CITY OF ALBUQUERQUE

Re: Brio Sandia Apartment
11930 Menaul Blvd. NE
Traffic Circulation Layout
Architect's Stamp 12-17-21 (H22-D029)

Based upon the information provided in your submittal received 01-14-22, the above referenced plan cannot be approved for Building Permit until the following comments are addressed:

A1 ARCHITECTURAL SITE PLAN
SCALE: 1/16" = 1'-0"

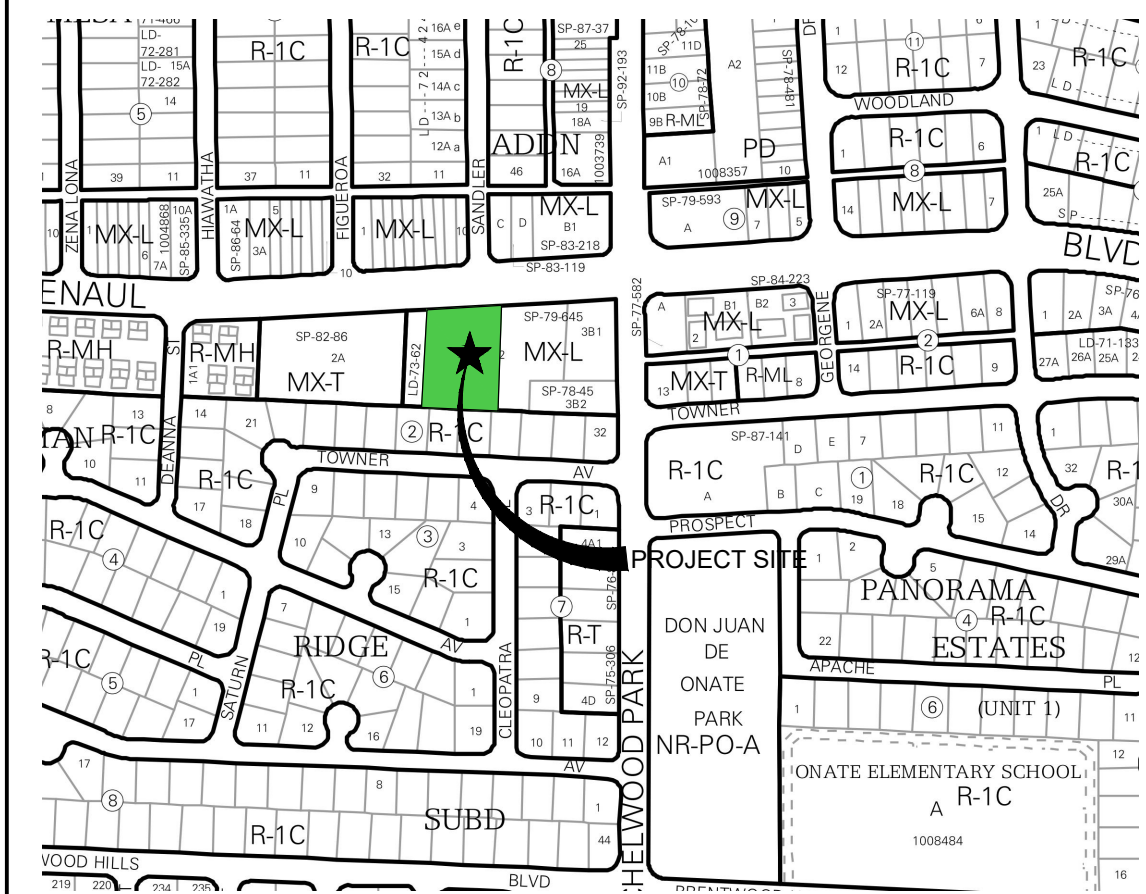
1. Provide width for the both existing drive pad entrance.
2. Maximum access width for arterial, collector, and local streets are as follows:

3. According to your parking calculation, you didn't provide 4 ADA parking spaces, Motorcycle parking spaces, and Bicycle racks. Please provide all required parking spaces.

4. Per DPM, a 6 ft. wide ADA accessible pedestrian pathway is required from EACH ADA parking stall access aisles to the building entrances. Please clearly show this pathway and provide details.

10. All one-way drives shall have "One Way" and "Do Not Enter" signage and pavement markings. Please show detail and location of posted signs and striping.

11. Provide face sign details for Motorcycle and for "DO NOT ENTER" sign.
 12. Add a note stating "All broken or cracked sidewalk must be replaced with sidewalk and curb & gutter." A build note must be provided referring to the appropriate City Standard drawing.
